Corrigendum: Global Hydrogen Review 2021

Issued: 25 November 2021

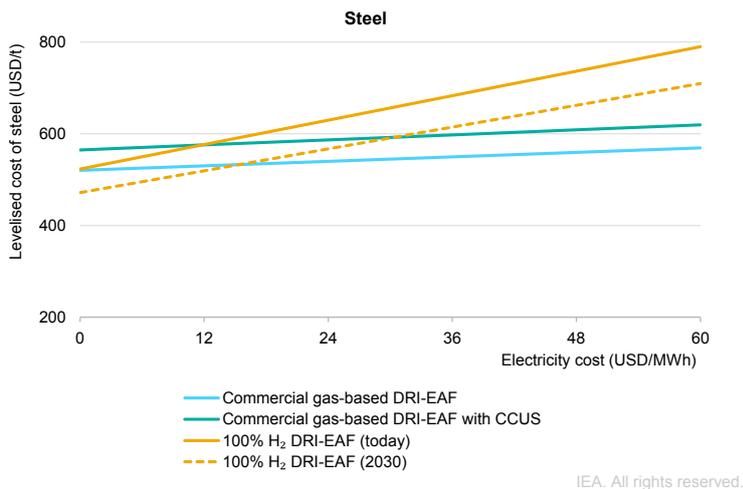
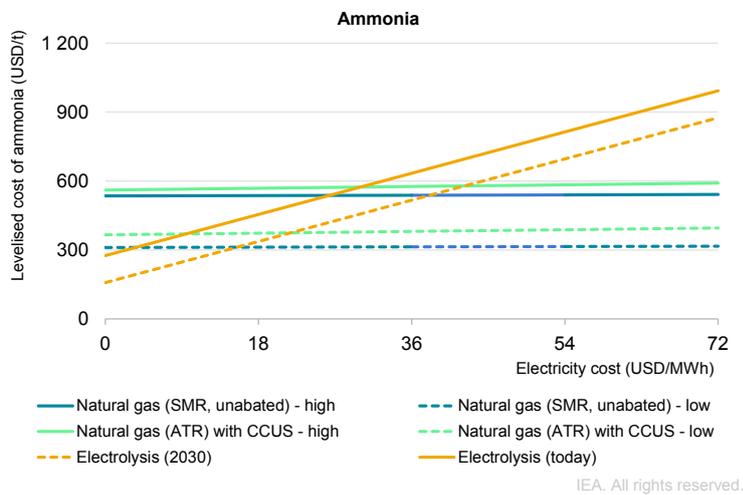
On **page 66**, replace figures with these updated ones:

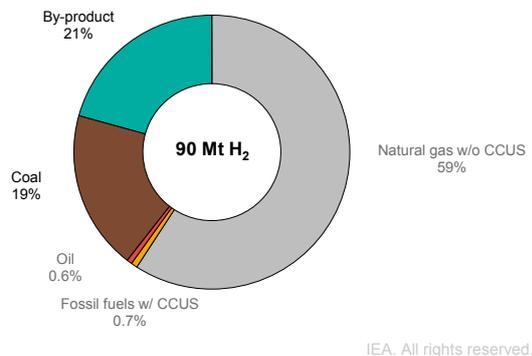
On **page 108**, the figure was updated:

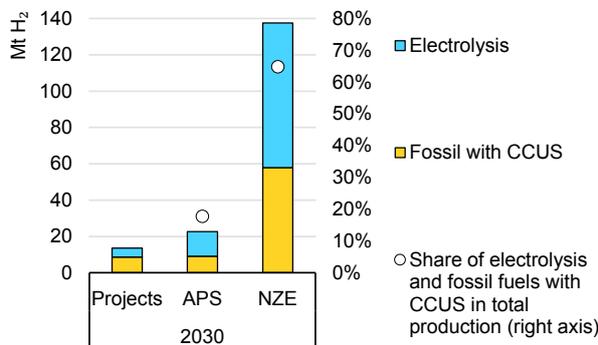
On **page 110**, the figure was updated:
